Subject: Response to Request for Additional Information Regarding Risk Informed Inservice Inspection Relief Requests for Braidwood Station, Units 1 and 2, and Byron Station, Units 1 and 2

Braidwood Station, Units 1 and 2
Facility Operating License Nos. NPF-72 and NPF-77
NRC Docket Nos. STN 50-456 and STN 50-457

Byron Station, Units 1 and 2
Facility Operating License Nos. NPF-37 and NPF-66
NRC Docket Nos. STN 50-454 and STN 50-455

Response to Request for Additional Information

Figure RAI-Br.13: Comparison of Inspection Effectiveness Factors for EPRI RISI Exams at Braidwood Units 1 and 2*

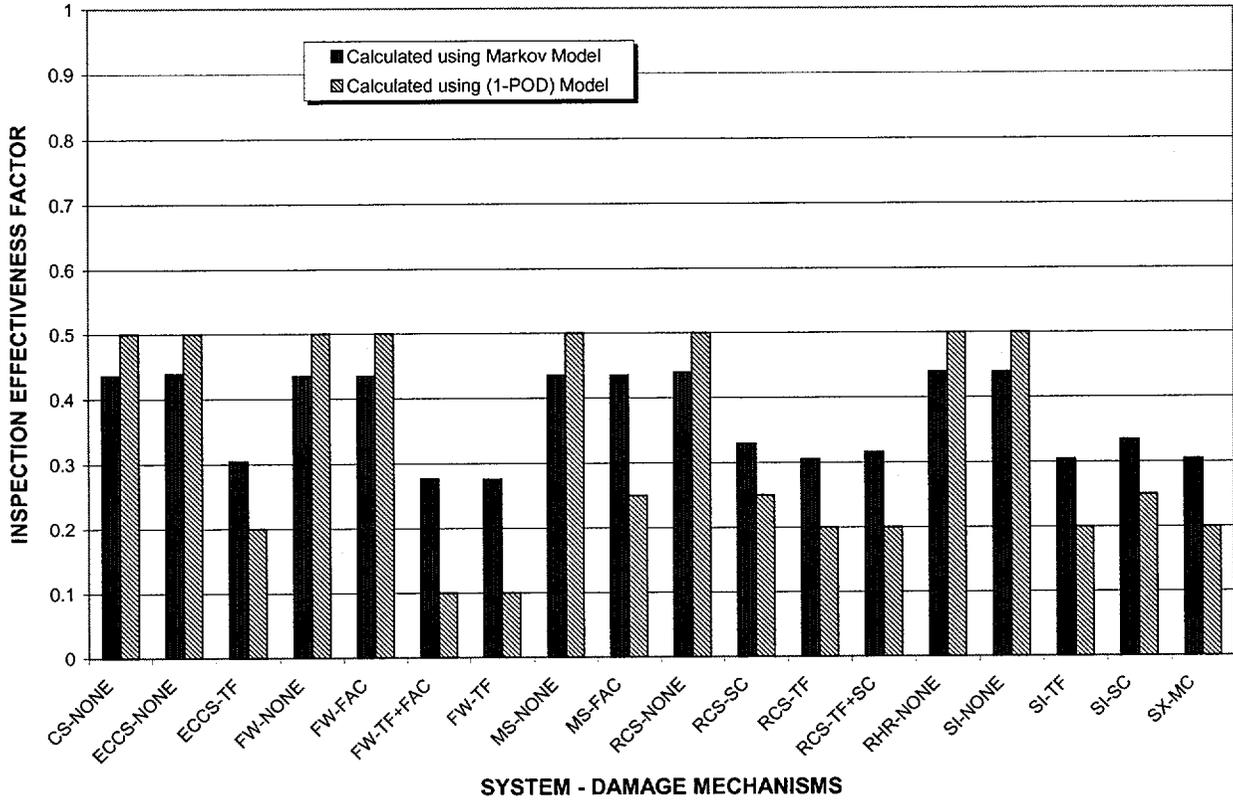
It is the staff's understanding that the Markov calculations include calculating an "inspection effectiveness factor" for use in equation 3-9 of EPRI-TR 112657. Please provide the distribution of inspection effectiveness values calculated and a discussion on how these values compare with the direct use of the probability of detection estimates.

A tabulation of all the unique inspection effectiveness factors for all pipe segments evaluated within the scope of the RI-ISI evaluation for Braidwood Station Units 1 and 2 is presented in Table Br-13. For comparison purposes, the corresponding POD values that were used were presented along with their complements that provide the alternative method of computing the inspection effectiveness factor. A plot that compares the two approaches to computing the inspection effectiveness factors is provided in Figure RAI-Br.13 for the RI-ISI exams.

As seen in these exhibits, there is relatively good agreement between these alternative approaches to estimating the inspection effectiveness factors. When the POD values are approximately .50, the Markov model predicts a higher level of inspection effectiveness, as reflected in lower inspection effectiveness factors. For higher POD values, the Markov model predicts a lower level of inspection effectiveness, as reflected in higher inspection effectiveness factors. Details documenting the inputs to computing these factors are discussed in response to RAI-Br. 12 above.

However, it is noted that in the context of developing order of magnitude estimates of risk impacts, both methods provide comparable results as seen in Table RAI-Br.13 and Figure RAI-Br.13.
